Medworth Energy from Waste Combined Heat and Power Facility

PINS ref. EN010110
Document Reference Vol.13.3
Revision: 1.0
Deadline: N/A
June 2023

Environmental Statement Chapter 6 Appendix 6B Transport Assessment Addendum

Cromwell Road/New Bridge Lane Signal
Scheme - Swept path analysis

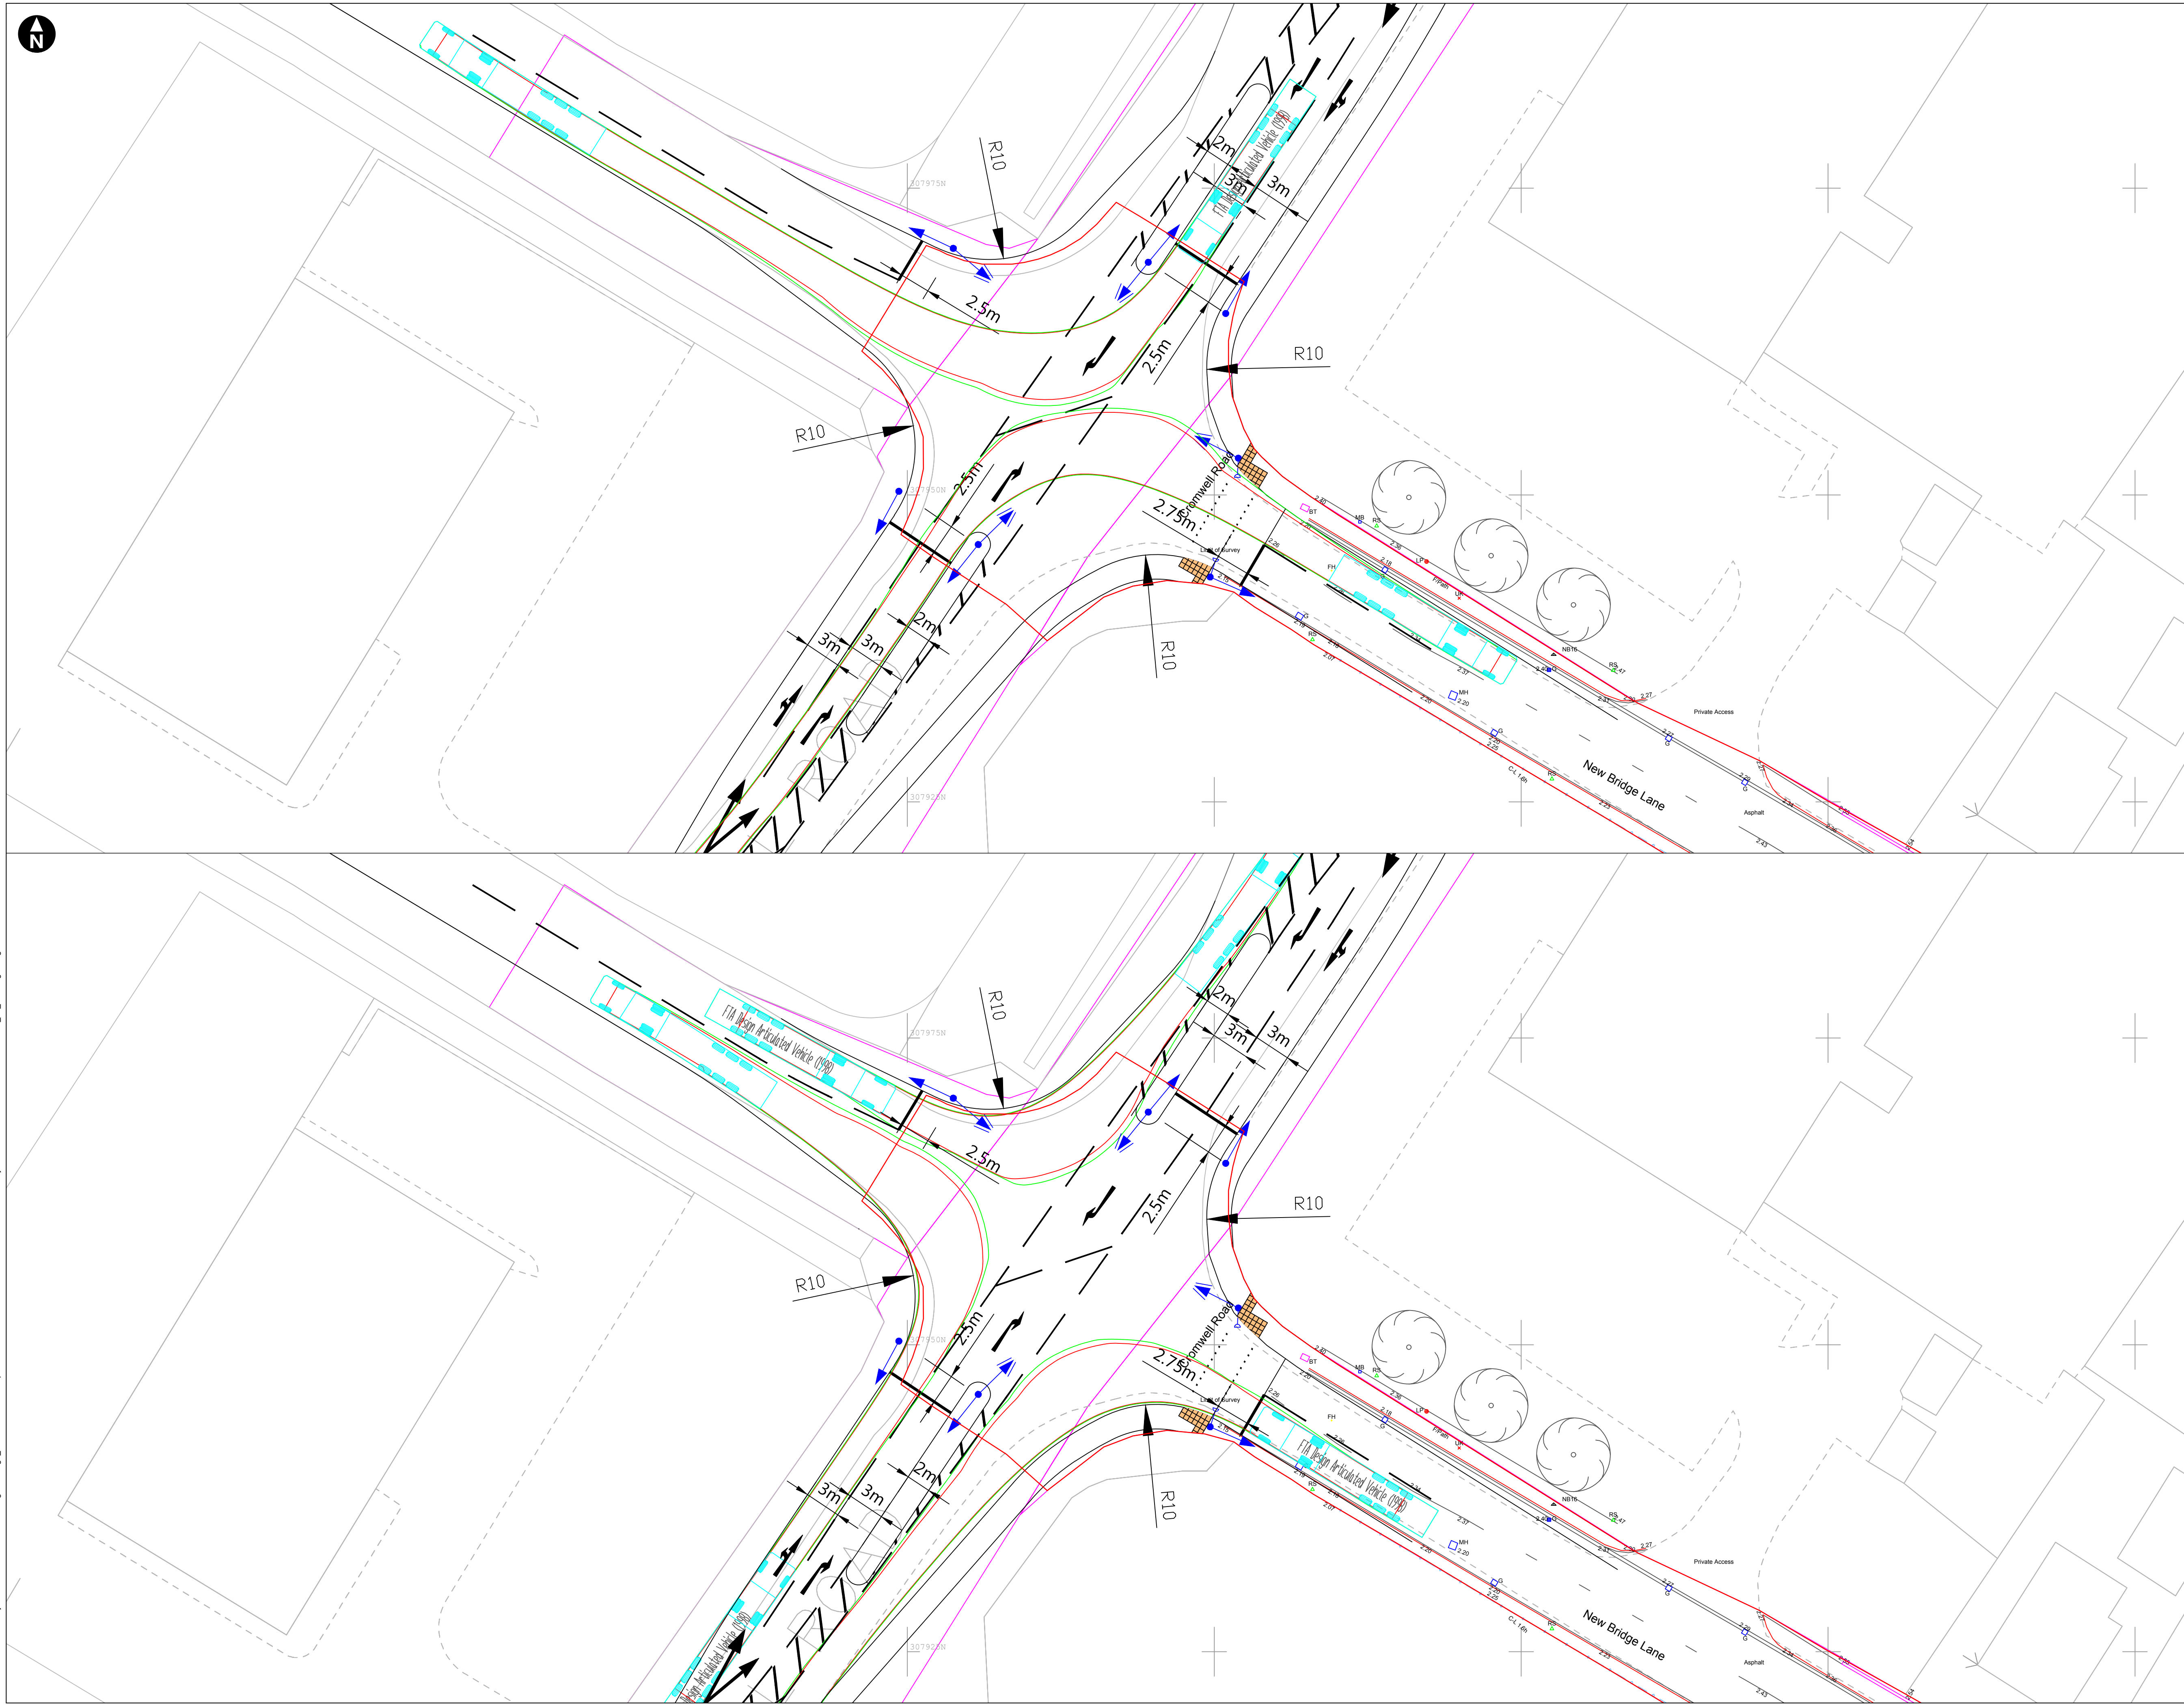
The lane widths provided at the proposed junctions are 3m wide. The swept path drawings provided for a 16.5m articulated vehicle at some locations show a vehicle overhang on the lane markings or traffic island. During the site visit, other types of larger vehicles were observed using the junction.

Where swept path drawings show an overhang on the traffic island, this may reduce the lateral clearance to signal poles. Insufficient lateral clearance could result in vehicles colliding with the traffic signal damaging or rotating the signal leading to drivers not seeing the traffic signal aspect and failing to stop at the junction resulting in T-bone collisions.

RSA Problem	RSA Recommendation	Design Organisation Response	Overseeing Organisation Response	Agreed RSA Action
<p>The existing junction of New Bridge Lane with Cromwell Road is to be signalised. The northbound and southbound approaches to the junction on Cromwell Road are two lane approaches with a right turning pocket.</p> <p>No signal staging diagrams have been provided so it is unclear how the signals will operate. If the straight ahead and right turn manoeuvres on both approaches on Cromwell Road are run together, it could lead to a gap seeking right turn increasing the risk of T-bone collisions.</p> <p>If there are separate phases for the right and straight-ahead manoeuvres on both approaches on Cromwell Road, this may lead to right turning traffic blocking the straight-ahead movements increasing the risk of shunts.</p>		CCC for review and approval.		
<p>Problem 12</p> <p>Location: New Bridge Lane / Cromwell Road junction</p> <p>Summary: Insufficient road width leading to side swipes, loss of control incidents or T-bone collisions</p> <p>The lane widths provided at the proposed junctions are 3m wide. The swept path drawings provided for a 16.5m articulated vehicle at some locations show a vehicle</p>	<p>It is recommended that vehicle tracking is undertaken for the largest vehicle anticipated to access the junction and if required, the kerb lines at the junction amended to accommodate the swept path of the largest vehicle.</p>	<p>The signal junction has been designed to accommodate anticipated HGV movements (B198 north and south to and from New Bridge Lane west arm and B198 south arm to and from New Bridge Lane east arm) using a 16.5m long articulated HGV, the maximum legal length of</p>

RSA Problem	RSA Recommendation	Design Organisation Response	Overseeing Organisation Response	Agreed RSA Action
<p>overhang on the lane markings or traffic island. During the site visit, other types of larger vehicles were observed using the junction.</p> <p>If adequate lane widths are not provided these could lead to side swipe collisions. Larger vehicles may also overrun the kerbs leading to loss of control incidents.</p> <p>Where swept path drawings show an overhang on the traffic island, this may reduce the lateral clearance to signal poles. Insufficient lateral clearance could result in vehicles colliding with the traffic signal damaging or rotating the signal leading to drivers not seeing the traffic signal aspect and failing to stop at the junction resulting in T-bone collisions.</p>		<p>an articulated vehicle within the UK.</p> <p>The proposed kerb line on Cromwell Road Northbound north east of New Bridge Lane (North) approach has been amended to provide a straight alignment for straight ahead traffic from Cromwell Road northbound.</p> <p>The swept path of the 16.5m articulated HGV through the junction are within the proposed lanes, only a marginal overhang on Cromwell Road South approach but the likelihood of two 16.5m artic lorry side by side would be low and one of them is likely to hang back to provide enough space for the other lorry to complete its turning manoeuvre.</p>

RSA Problem	RSA Recommendation	Design Organisation Response	Overseeing Organisation Response	Agreed RSA Action
<p>Location: New Bridge Lane / Cromwell Road junction</p> <p>Summary: Inadequate carriageway width leading to vehicle overrunning kerbs and loss of control incidents or collisions between vehicles and pedestrians.</p> <p>Vehicle tracking have been provided for a 16.5m articulated vehicle. During the site visit, a number of larger vehicles including a transporter and an HGV recovering another HGV. It was also observed that an HGV turning left out of New Bridge Lane swung into the opposing carriageway to complete the turning manoeuvre.</p> <p>If adequate carriageway width is not provided at the junction, this could lead to larger vehicles overrunning the kerb resulting in loss of control incidents or collisions between vehicles and pedestrians on the footway.</p>	<p>vehicle anticipated to access New Bridge Lane and if required, the kerb lines at the junction amended to accommodate the swept path of the largest vehicle.</p>	<p>HGV movements (B198 north and south to and from New Bridge Lane west arm and B198 south arm to and from New Bridge Lane east arm) using a 16.5m long articulated HGV, the maximum legal length of an articulated vehicle within the UK. Lane widths and Kerb lines are based on the swept path of the 16.5m articulated HGV through the junction. It is noted that a vehicle transporter was witnessed accessing New Bridge Lane east during the onsite audit, this rigid HGV is likely to be an arrangement approximately 11-12m in length and would be comfortably accommodated within the junction.</p>

Figure 2 - Extract from drawing 41310-WOOD-XX-XX-DR-OT-0026_S0_P03

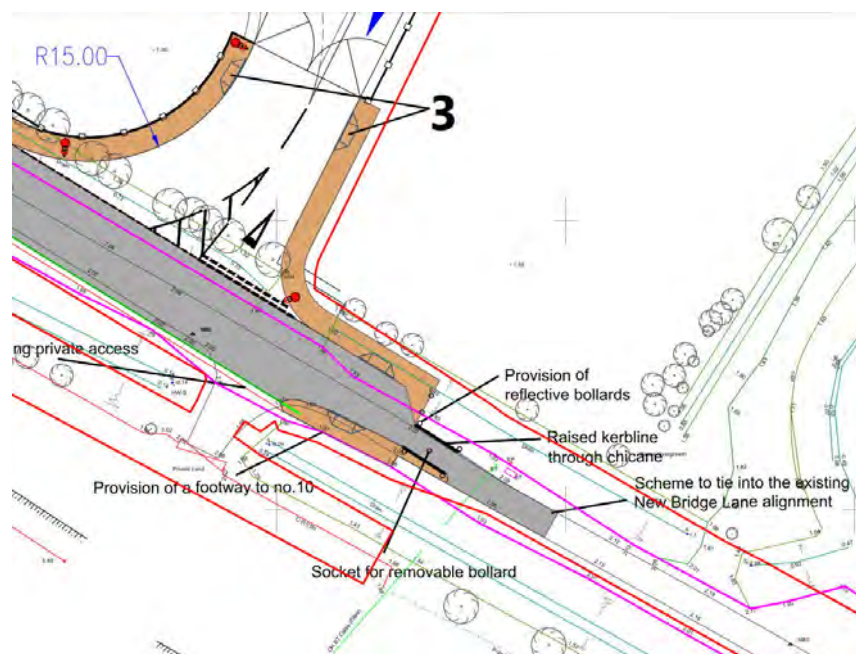
Summary: Poor access visibility leading to collisions between cyclists/pedestrians and vehicles.

The proposed access to the Waste Heat Power Facility is located off New Bridge Lane where there is matured vegetation. No visibility splay drawings have been provided so it is unclear what visibility will be achieved at the access. The carriageway to the east of the access is restricted to non-motorised users use.

If adequate visibility is not provided from the access, drivers may fail to see pedestrians or cyclists approaching the access leading to collisions involving vehicles and pedestrians/cyclists.

<p>Problem 2</p> <p>Location: Waste Heat Power Facility Access – New Bridge Lane (East)</p>	It is recommended adequate visibility is provided to and from the access.	Visibility splay for the proposed site access is provided on drawing 41310-WOOD-XX-XX-DR-OT-0026_S0_P03. The splay provided is 2.4

RSA Problem	RSA Recommendation	Design Organisation Response	Overseeing Organisation Response	Agreed RSA Action
<p>Summary: Poor access visibility leading to collisions between cyclists/pedestrians and vehicles.</p> <p>The proposed access to the Waste Heat Power Facility is located off New Bridge Lane where there is matured vegetation. No visibility splay drawings have been provided so it is unclear what visibility will be achieved at the access. The carriageway to the east of the access is restricted to non-motorised users use.</p> <p>If adequate visibility is not provided from the access, drivers may fail to see pedestrians or cyclists approaching the access leading to collisions involving vehicles and pedestrians/cyclists.</p>		<p>x 70m based on New Bridge Lane being subject to a revised 30mph speed limit and is in accordance with Table 2.10 of CD 109 and Section 3 of CD123.</p>		
<p>Problem 3</p> <p>Location: Waste Heat Power Facility Access – New Bridge Lane (East).</p> <p>Summary: Poor access visibility leading to collisions between vehicles and pedestrians.</p> <p>There is an inset uncontrolled crossing located near the gate on the proposed access into the Waste Heat Power Facility. Drawing 41310-WOOD-XX-XX-DR-OT-0026_S0_P03 provided shows a fence behind the footway to the west of the access, as well as a gate, and internal fence. It is unclear from the drawings what the boundary treatment would be.</p>	<p>It is recommended that the crossing point is relocated, or adequate visibility provided to and from the crossing points.</p>	<p>As per drawing 41310-WOOD-XX-XX-DR-OT-0026_S0_P03 the fence line on the western side of the access has been realigned to provide a suitable visibility splay for pedestrians crossing at the site access. Visibility splay for pedestrians is 40m for a road with a 30mph speed limit based on CCC Highways Development Management – General Principles for</p>

Figure 3 - Extract from drawing 41310-WOOD-XX-XX-DR-OT-0026_S0_P03

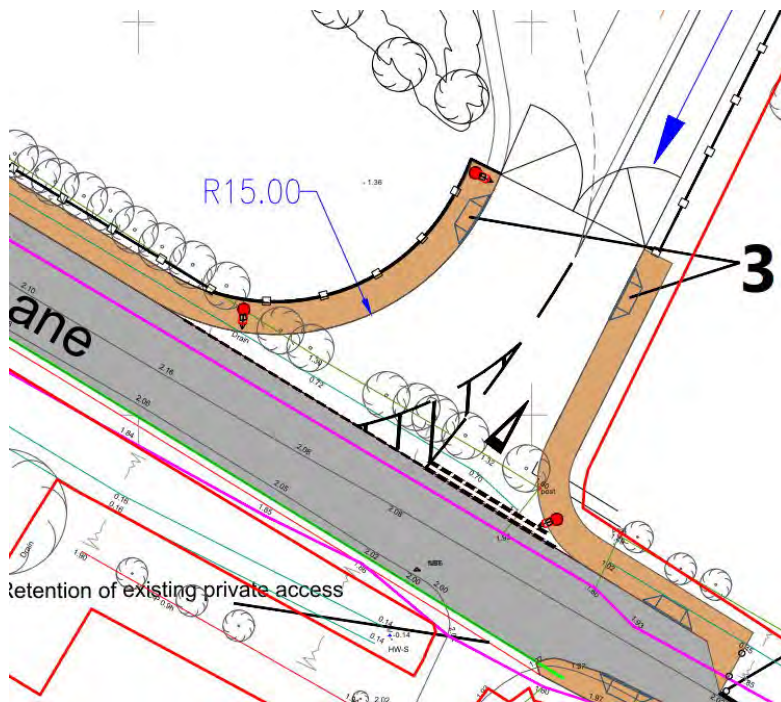
Summary: Poor access visibility leading to collisions between vehicles and pedestrians

There is an inset uncontrolled crossing located near the gate on the proposed access into the Waste Heat Power Facility. Drawing 41310-WOOD-XX-XX-DR-OT-0026_S0_P03 provided shows a fence behind the footway to the west of the access, as well as a gate, and internal fence. It is unclear from the drawings what the boundary treatment would be.

Pedestrians crossing at this location may have reduced visibility of vehicles approaching from New Bridge Lane or exiting the Waste Heat Power Facility due to the boundary treatment and drivers may not see pedestrians' step into the carriageway to cross leading to collisions between vehicles and pedestrians.

RSA Problem	RSA Recommendation	Design Organisation Response	Overseeing Organisation Response	Agreed RSA Action
<p>Pedestrians crossing at this location may have reduced visibility of vehicles approaching from New Bridge Lane or exiting the Waste Heat Power Facility due to the boundary treatment and drivers may not see pedestrians' step into the carriageway to cross leading to collisions between vehicles and pedestrians.</p> <p>Pedestrians may also choose to cross at the mouth of the access due to the proposed crossing being away from their desire line. Drivers may not anticipate pedestrians crossing at this location increasing the risk of collisions between vehicles and pedestrians.</p>		<p>Development, Figure 5, and Section 2.2.</p> <p>The position of the dropped kerb crossings will be moved south, and a pedestrian refuge will be provided mid junction.</p> <p>The proposed location of the new crossing is shown on 41310-WOOD-XX-XX-DR-OT-0026_S0_P03.</p>

PROBLEM LOCATION PLANS

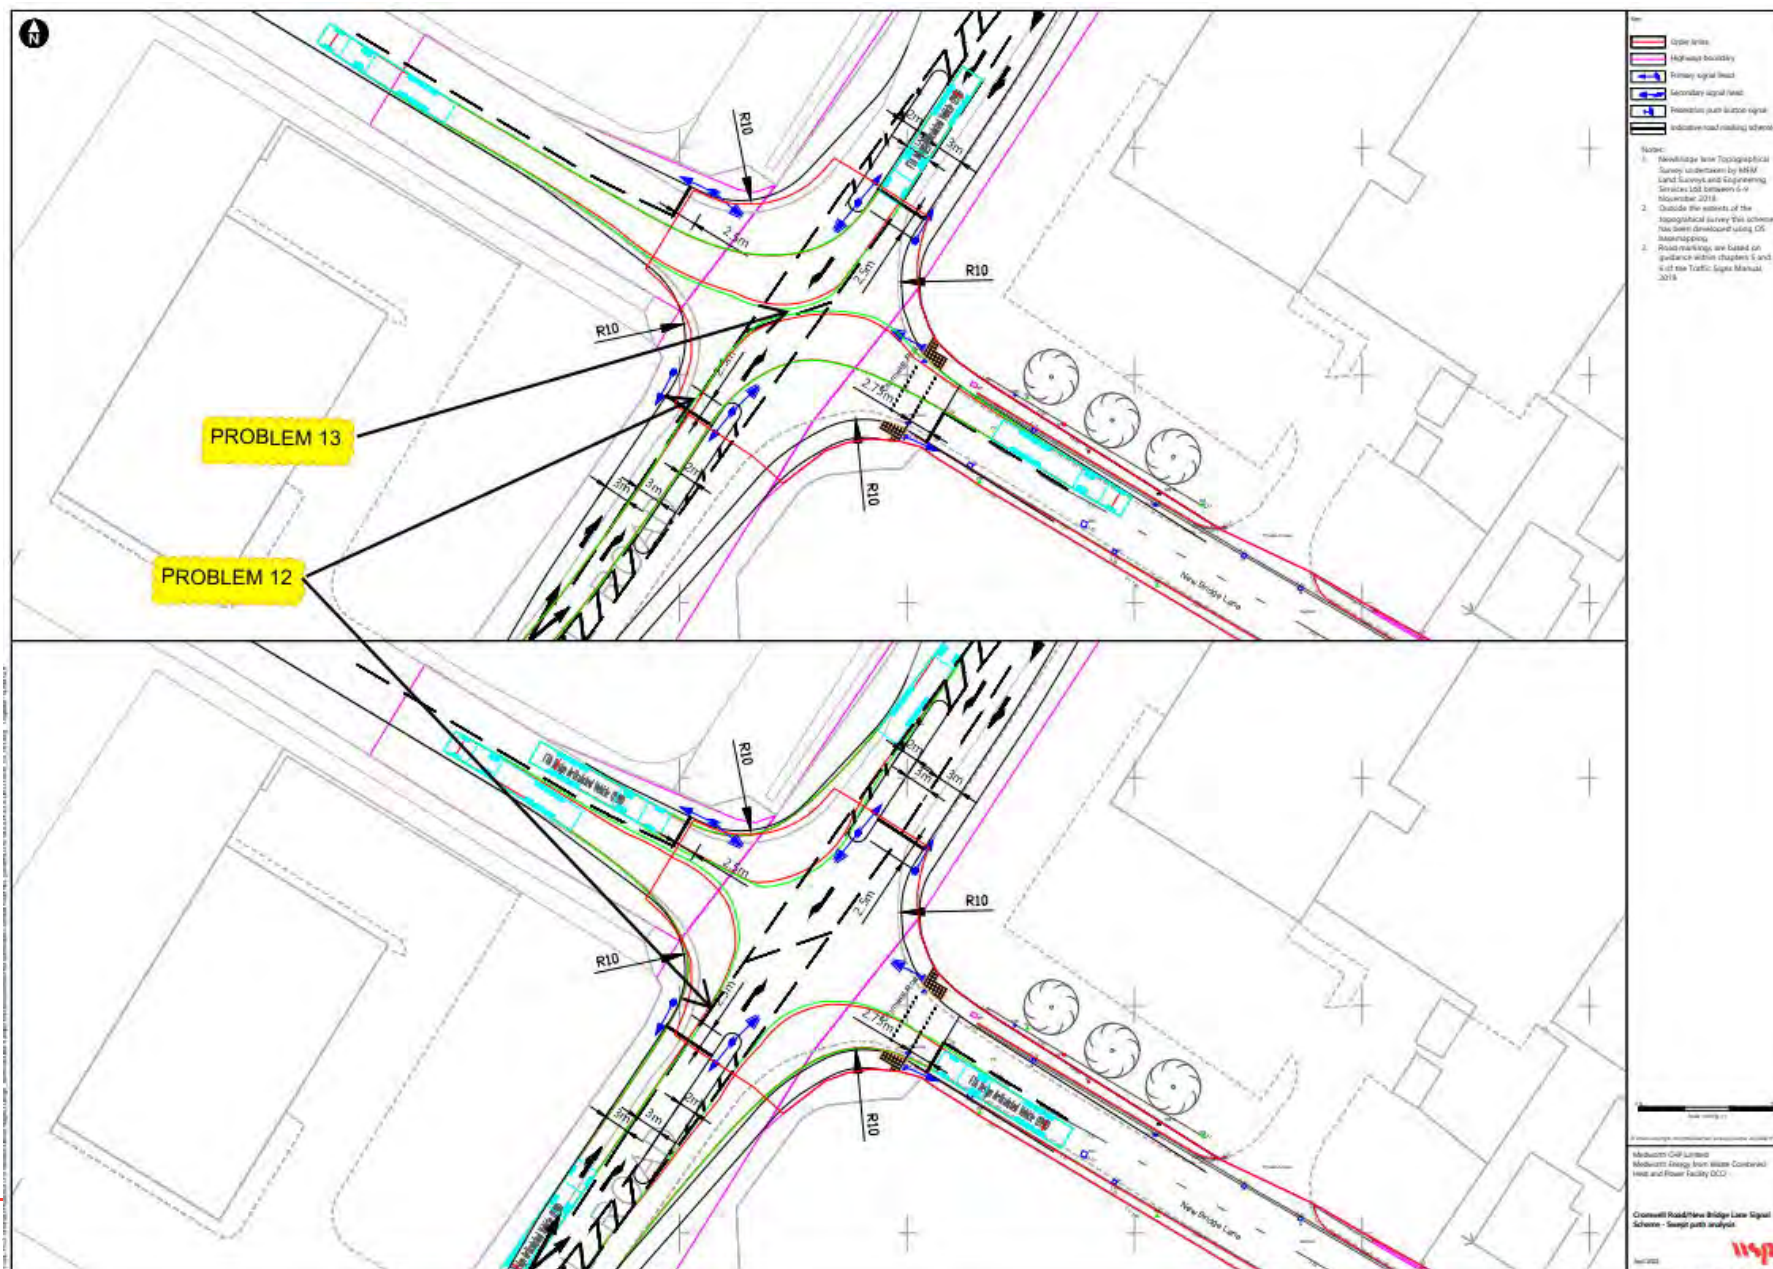
2.1.6. All comments and recommendations are referenced to the design drawings and the locations have been indicated on the plan located in Appendix B.
